Product Change Notification

113176 - 00

Change Notification #: 113176 - 00
Change Title: Intel® Dual Band Wireless-AC 7265 and Intel® Dual Band Wireless-N 7265 SKUs: 7265.NGWG; 7265.NGWANG; 7265.NGWG.NV; 7265.NGWBNG; 7265.NGWG.S; 7265.NGWANG.S
PCN 113176-00, Product Design Update EEPROM settings
Date of Publication: August 1, 2014

Mock Label – Before/After

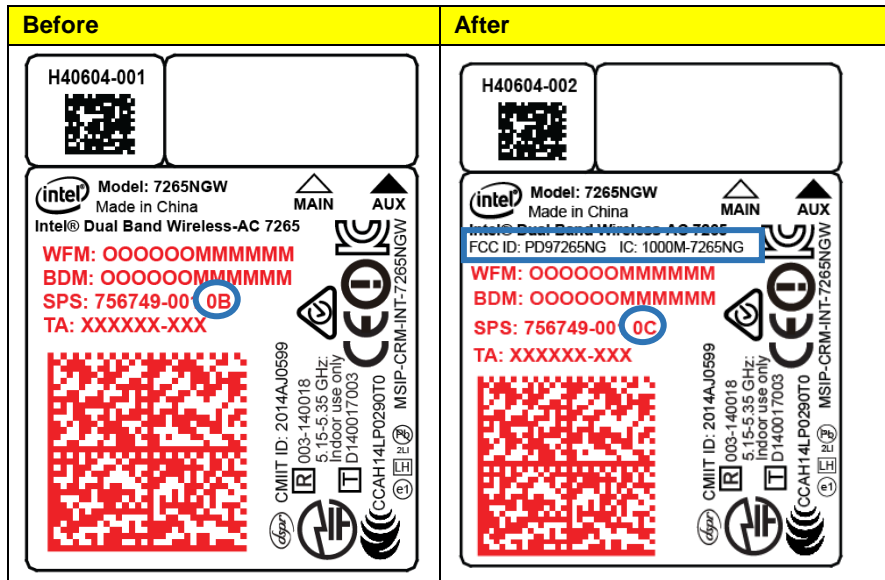
EEPROM settings on Intel Dual Band Wireless-AC 7265 and Intel Dual Band Wireless-N 7265 SKUs will be updated to meet FCC regulatory requirements and allow for world-wide shipment.

The Intel Tracking revision will be changed as follows on the following product code:

Product Code	Current Rev	New Rev
7265.NGWG	0B	0C
7265.NGWANG	0B	0C
7265.NGWG.NV	0B	0C
7265.NGWBNG	0A	0B
7265.NGWG.S	XX	XX
